RE: LOT 7 (60) BLACKWOOD RIVER DRIVE, NANNUP – PROPOSED SHORT-TERM RENTAL ACCOMMODATION AND COMMUNITY EVENT DAY USE - DEVELOPMENT APPLICATION

I refer to your letter dated 15 December 2025 regarding the submission of a Bushfire Management Plan (BMP) (Version 1.0), prepared by Bushfire Prone Planning and dated 17 October 2025, for the above proposed development. The BMP is accompanied by a letter from the proponent dated 20 November 2025 in relation to the proposal.

DEVELOPMENT APPLICATION 60 BLACKWOOD RIVER DR, NANNUP

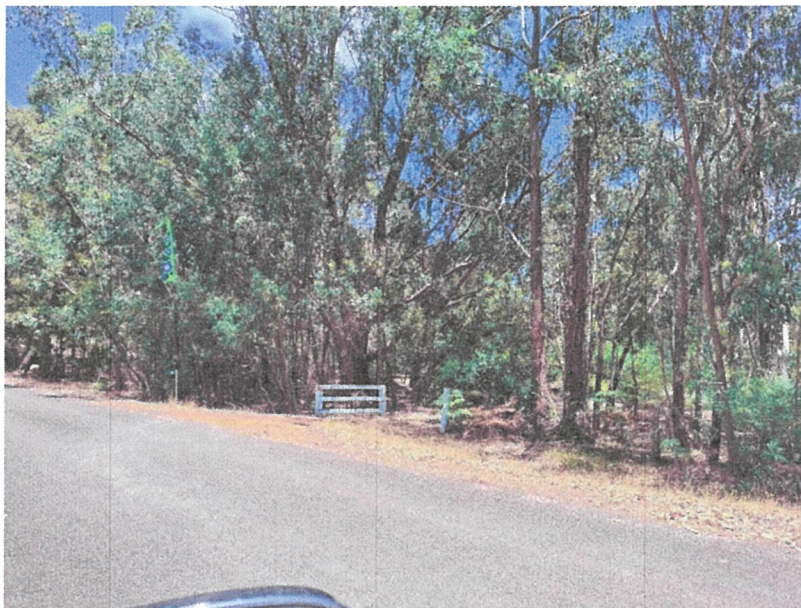
On the overhead plan (figure 2.1) it is indicated that a Firewater tank is to be located in an area behind the proposed accommodation unit #1. Access to this tank appears to be impeded by existing bus.

We feel that access will for appliances will be impeded by its close proximity to unit no 1 as well as the current amount of brush surrounding the area.

What will be the capacity of this tank? We suggest a minimum of 20,000Lts.

Our Brigade/CESM will need to be advised of what fittings will be used so that we can sourced any adaptors that are required.
